AMERICAN EAGLE

STOREFRONT ELEVATIONS

AMERICAN EAGLE OUTFITTERS
Forum Tec C.C.
Tepic, Nayarit

A.1.300

FIXTURE PLAN
SCALE: 1/4" = 1'-0"

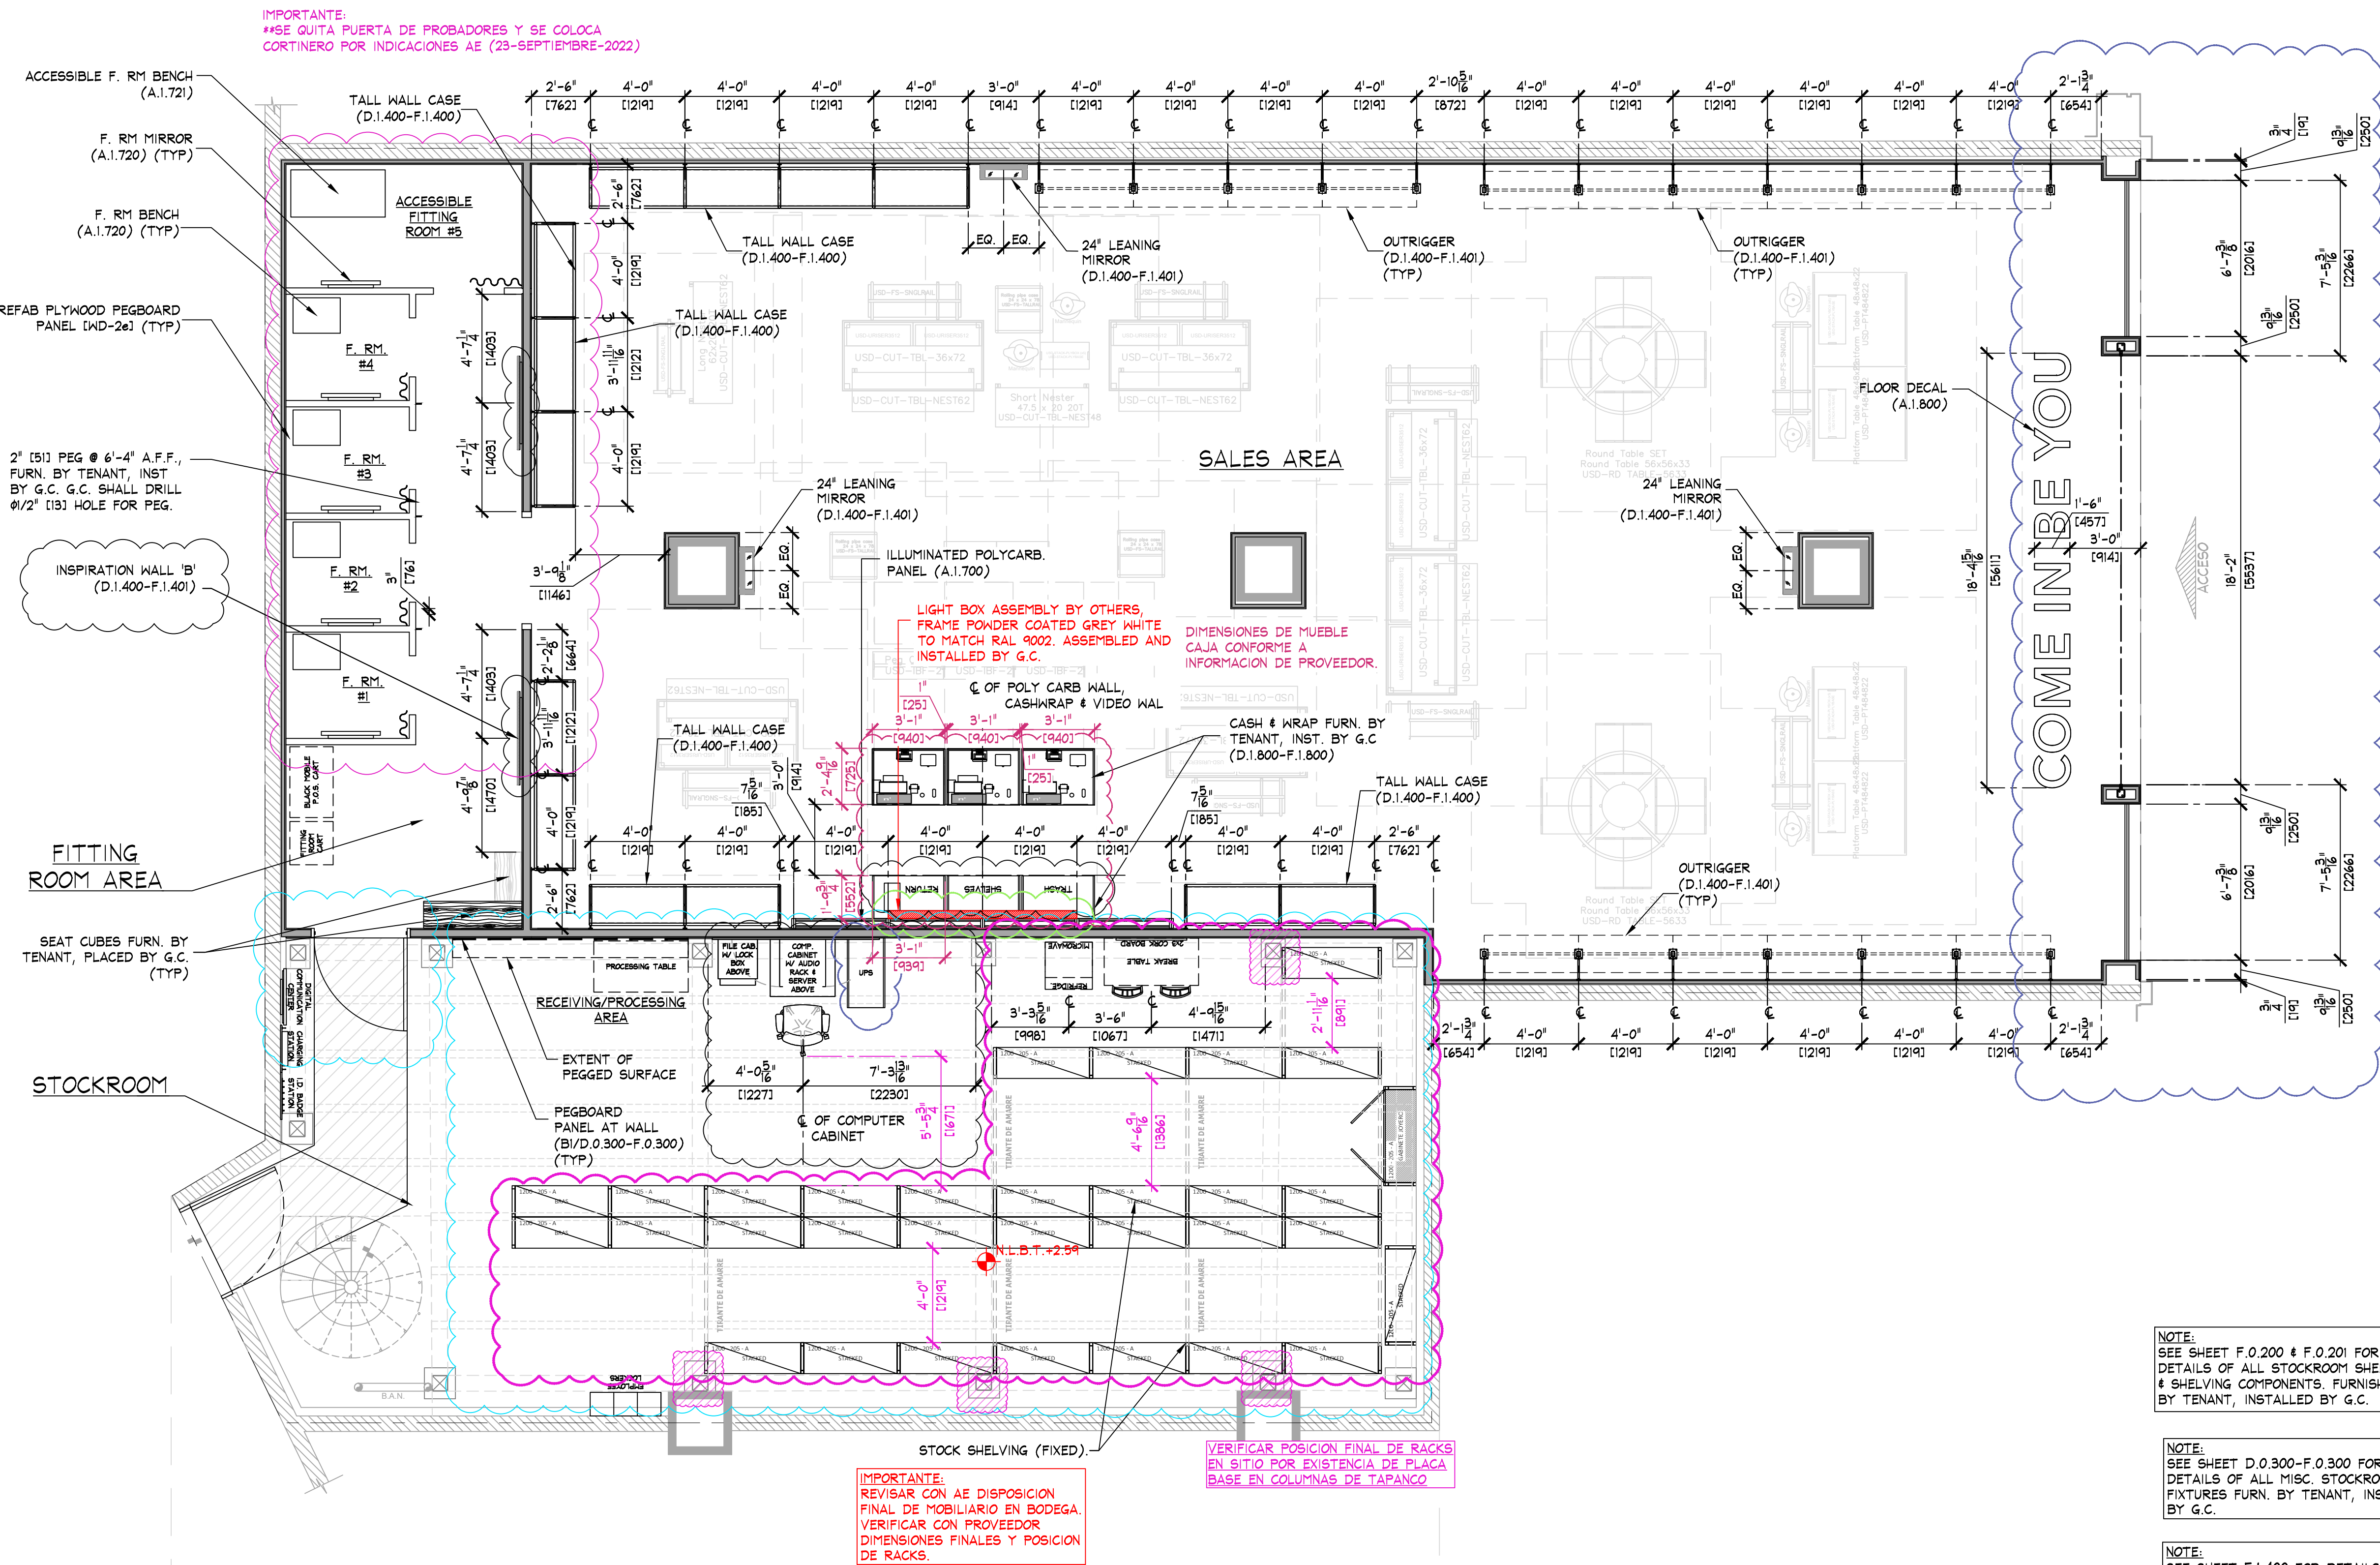
##ACTUALIZACION DE LAYOUT POR INDICACION DE AE (16-AGOSTO-2022)
EN PROBADORES: SE CAMBIA INSPIRATION WALL TIPO 'A' POR TIPO 'B'
EN AREA DE VENTA: SE AJUSTA CASHWRAP A 3 MODULOS
EN BODEGA: SE RETIRA MONTACARGAS Y SE REACOMODA MOBILIARIO Y RACKS
EN MEZZANINE: SE CANCELA AREA PARA BODEGA EN MEZZANINE

##ACTUALIZACION DE LAYOUT POR INDICACION DE AE (29-JULIO-2022)
EN PROBADORES: SE REUBICA PARTE DEL MOBILIARIO Y SE RECORRE EL ACCESO, DE MANERA QUE QUEDE EN LA PARTE TRASERA DE LA COLUMNA.
EN AREA DE VENTA: SE REUBICA ACCESO A PROBADORES Y MOBILIARIO.
EN BODEGA: SE RETIRA UNA SECCION DE RACKS PARA INTEGRAR MONTACARGAS EN PROYECTO.

##ACTUALIZACION DE ANAQUELES EN BODEGA Y GABINETE JOYERO, CONFORME INFORMACION RECIBIDA POR PROVEEDOR (07-OCT-2022)

####ACTUALIZACION LAYOUT POR INDICACION DE AE (12-OCTUBRE-2022)
EN BODEGA, SE QUITA EL GABINETE JOYERO, SE INDICA QUE SE ENCUENTRA DENTRO DE LOS RACKS REDHINTON, CONFORME A INFORMACION RECIBIDA POR PROVEEDOR.
SE CAMBIO EL ABATIMIENTO DE LA PUERTA DE ACCESO A BODEGA
SE CAMBIO EL AREA DE TABLEROS ELECTRICOS, DE PLANTA BAJA A MEZZANINE EXISTENTE

##ACTUALIZACION DE ANAQUELES EN BODEGA Y GABINETE JOYERO, CONFORME INFORMACION RECIBIDA POR PROVEEDOR (12-DICIEMBRE-2022). VERIFICAR POSICION FINAL DE RACKS EN SITIO POR EXISTENCIA DE PLACA BASE EN COLUMNAS DE TAPANGO

A STOREFRONT EXTERIOR ELEVATION
SCALE: 1/2" = 1'-0" (1/25)

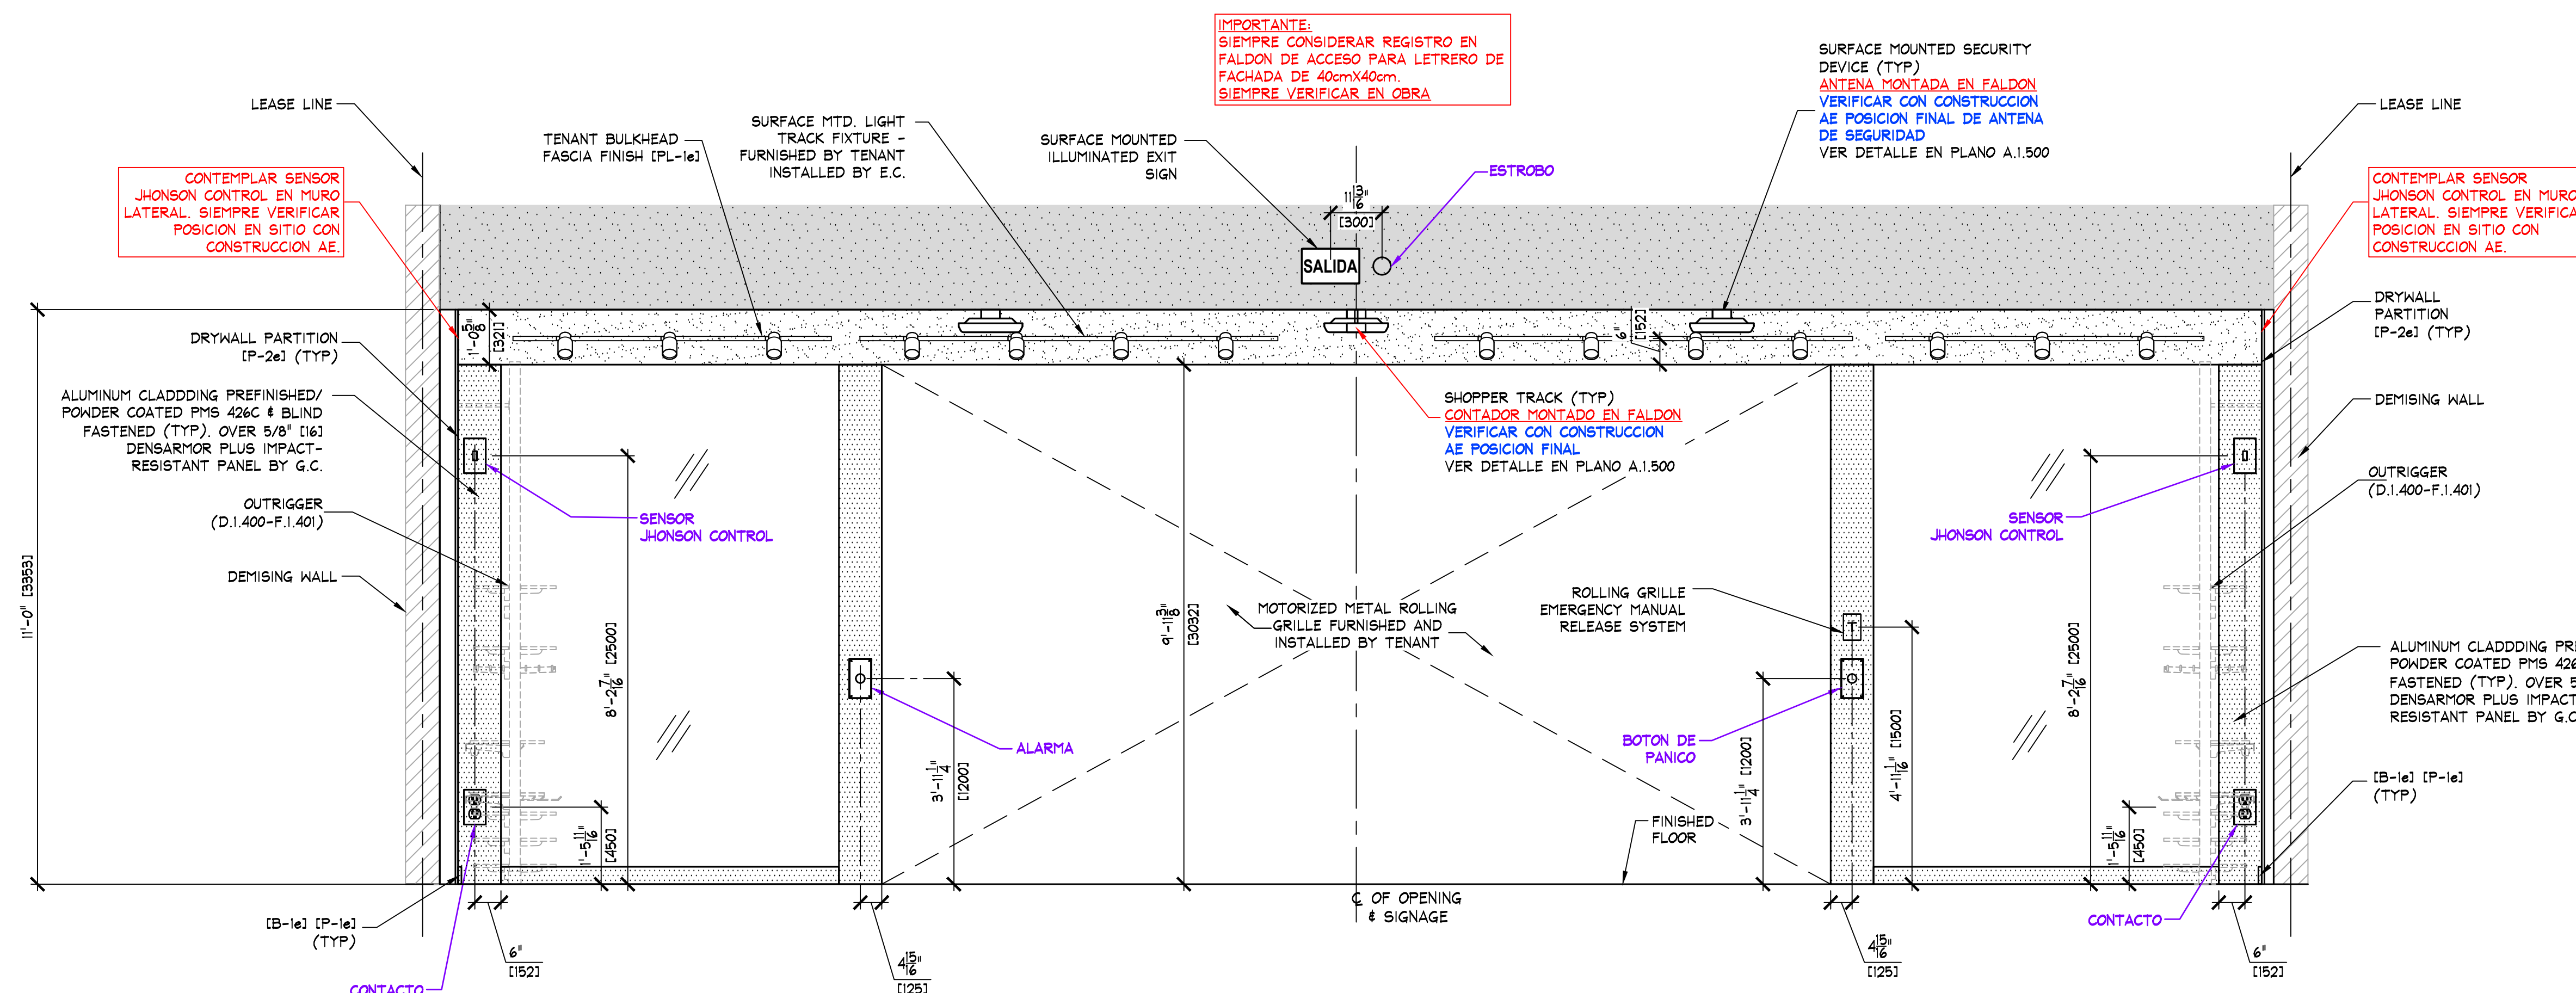
ACTUALIZACION DE FACHADA POR INDICACION AE (27-OCTUBRE-2022)
ACTUALIZACION DE FACHADA POR INDICACION AE (14-OCTUBRE-2022)
PROYECTO AJUSTADO EN FALDON DE ACCESO CON REDLINES RECIBIDOS POR AE (27-SEP-2022)
